**EASTERN MICHAUD FLATS  
POCATELLO, IDAHO  
SIMPLOT PLANT AREA  
DEWATERING PIT REMEDIAL  
ACTION**

**DEWATERING PIT  
SITE PLAN AND  
HAUL ROUTE**

DRAWING NO. **0121C-102** REV. NO. **0**  
SHEET **2** OF **4**

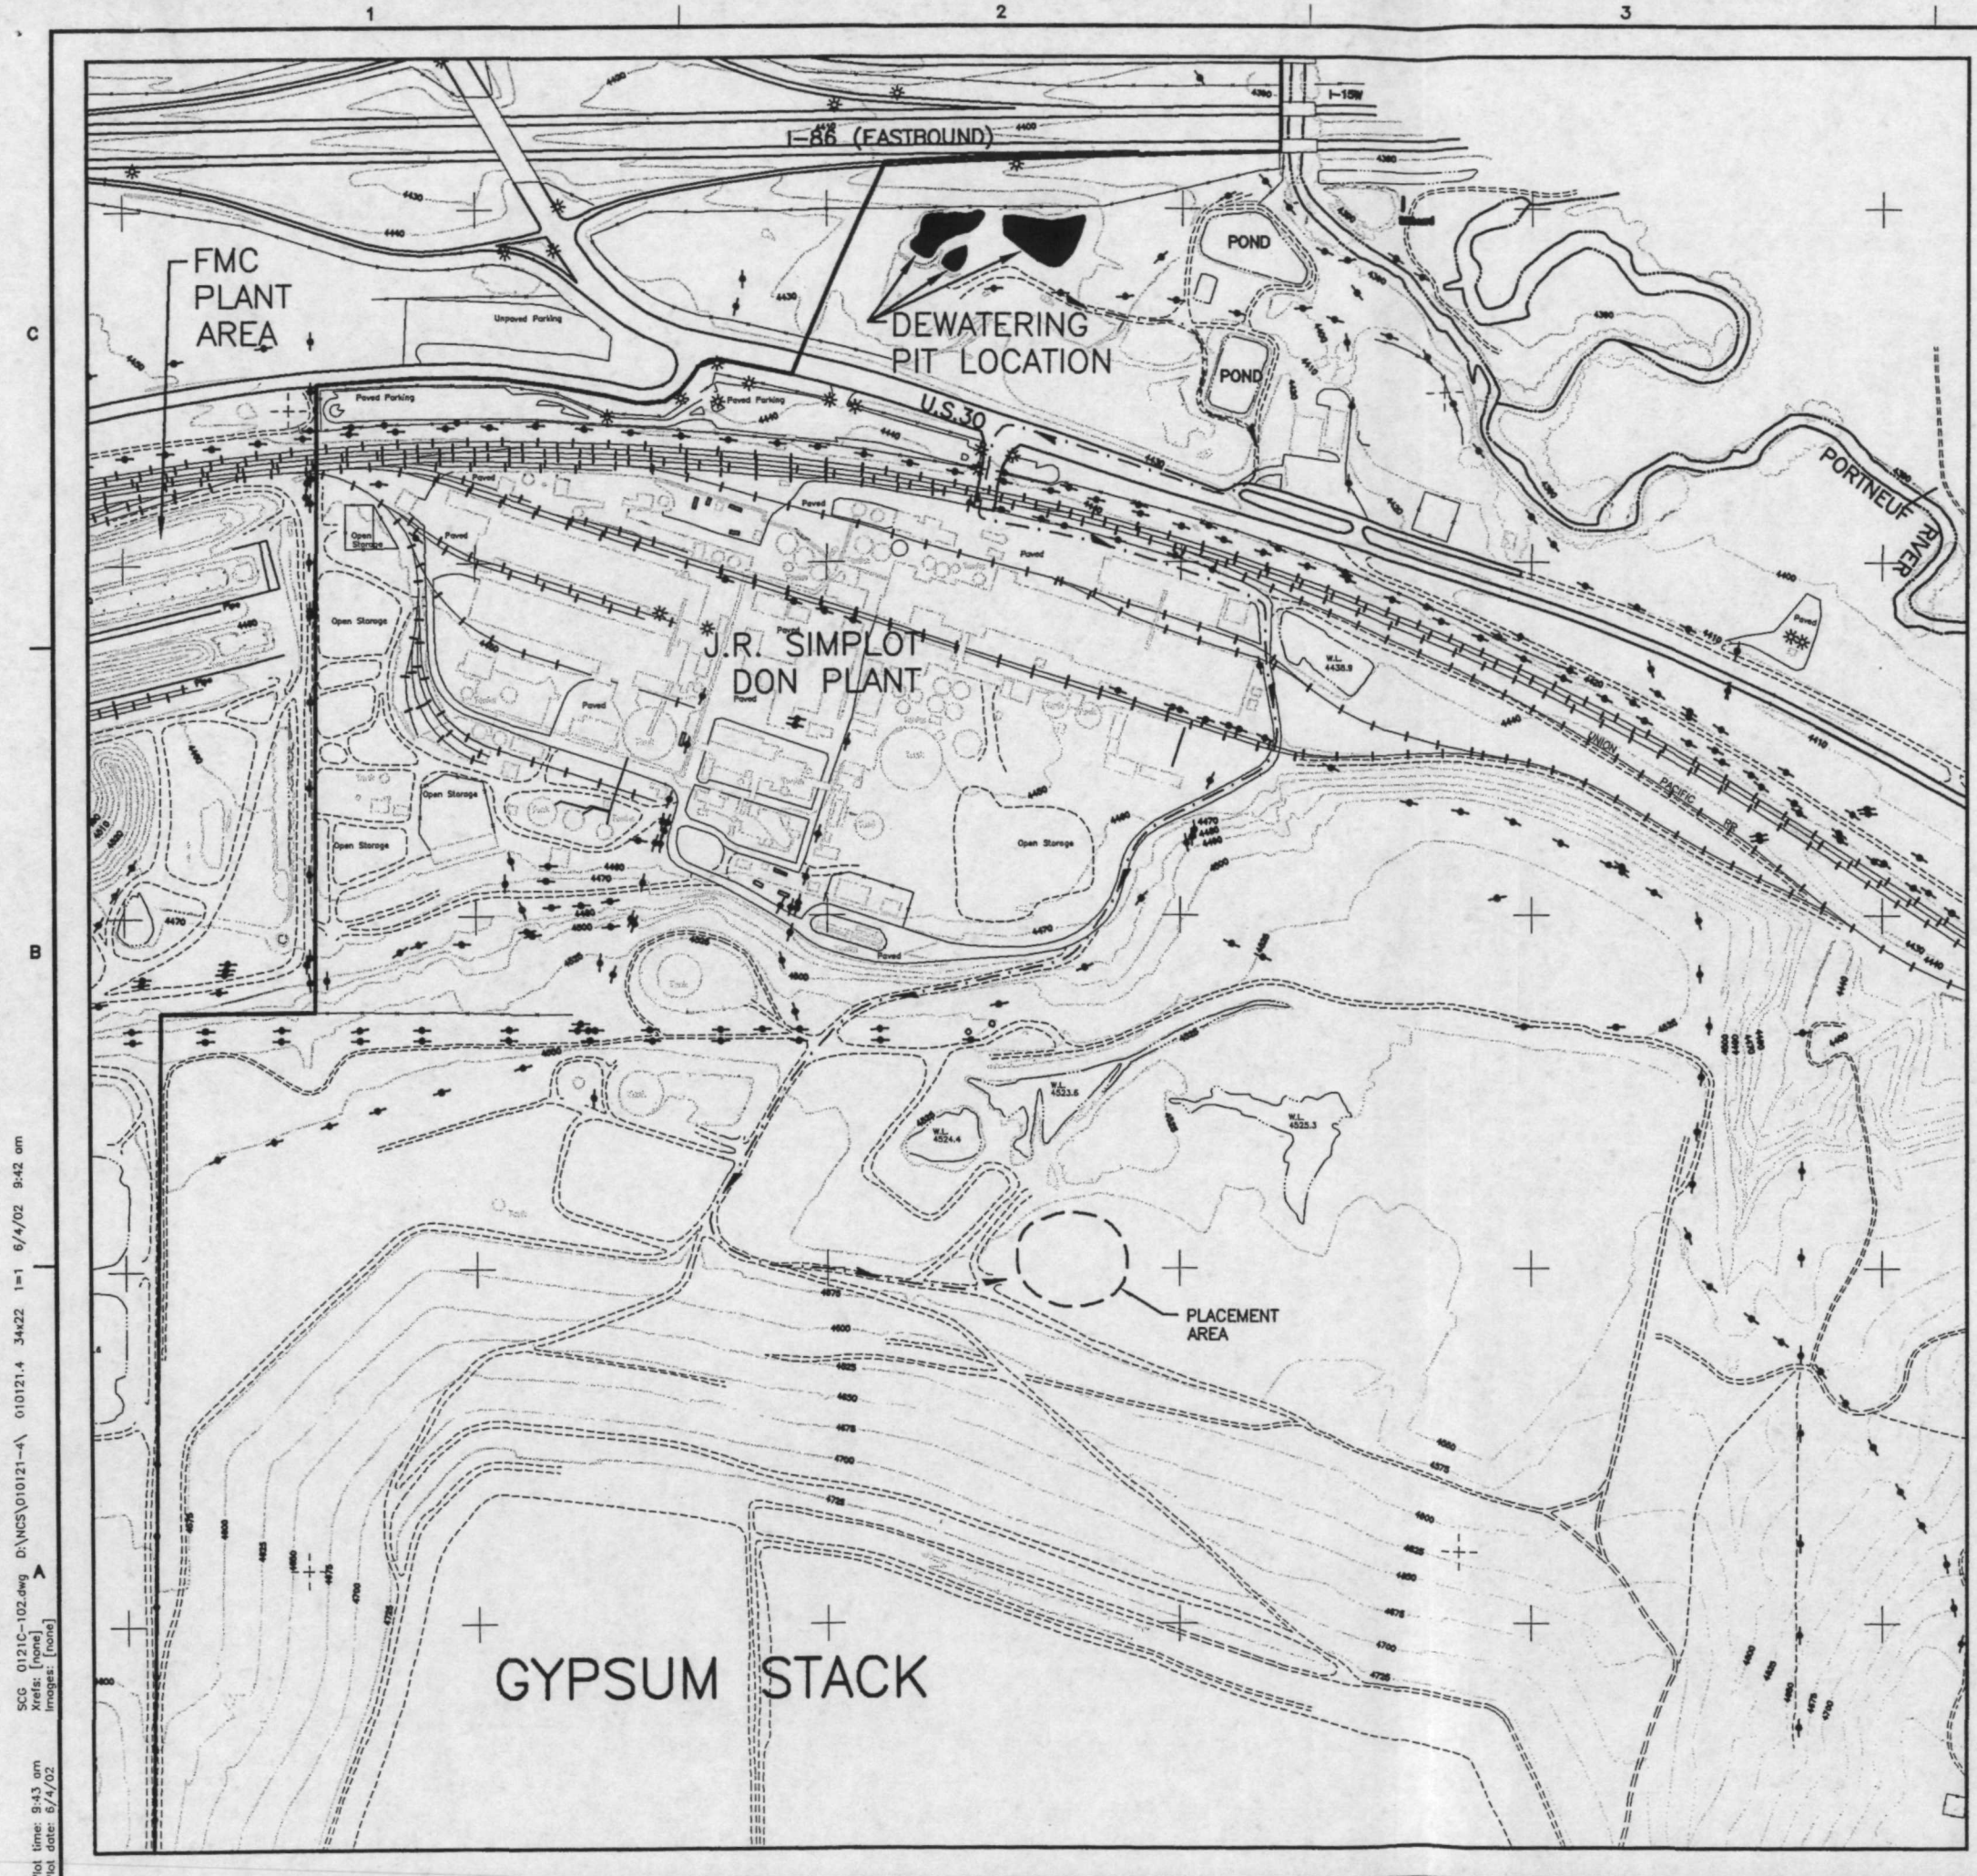
• WANT to do this work this fall.

TO DO ? or to dispose Dewatering Pit  
of rain on gyp stack?

*10% of source material is controlled -*
